City of Santa Fe, New Mexico

2025-010872-HDRB, 836 Don Cubero Ave, Don Gaspar Area Historic District, Contributing, Daniel Strongwater, agent for Anthony Cao, owner, requests status review with primary façade designation(s) if applicable.

Figure 1: Proposed Façade Diagram for Contributing Status at 836 Don Cubero Ave.

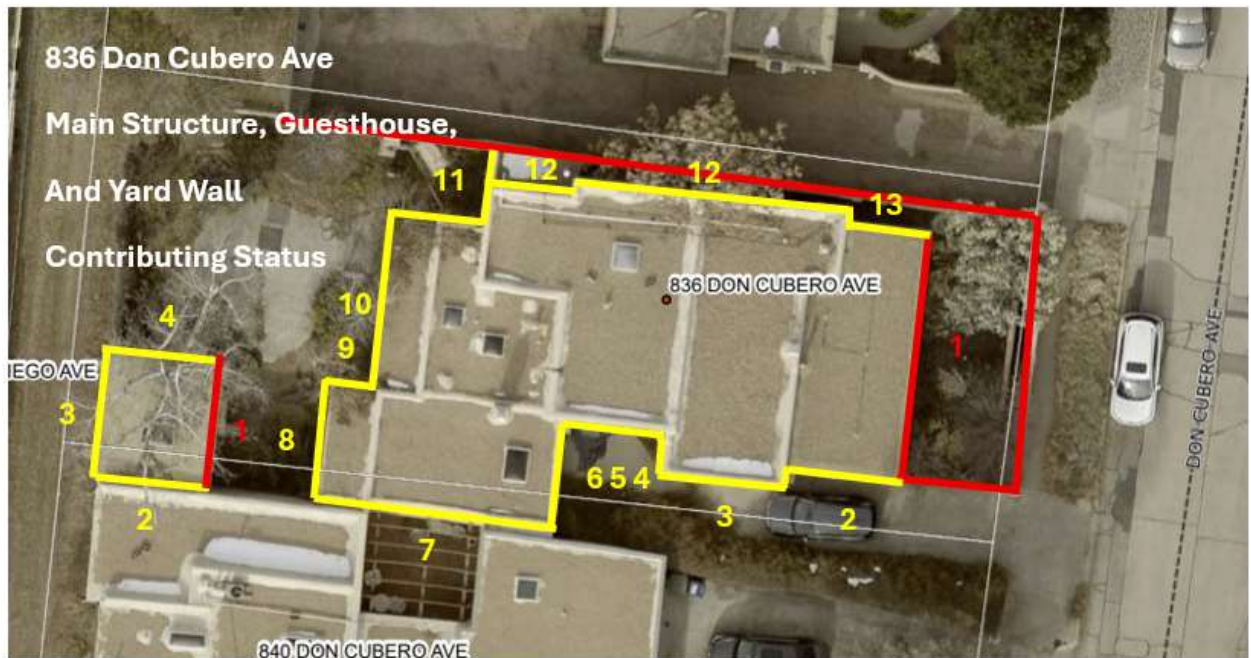
Staff recommends the historic status of the main structure and detached guesthouse be maintained as contributing with the east facades designated as primary as indicated as numbers one on the Proposed Façade Diagram and the yard wall designated as contributing, per 14-5.2(C) Designation of Significant, Contributing or Noncontributing Status Within Historic Districts.
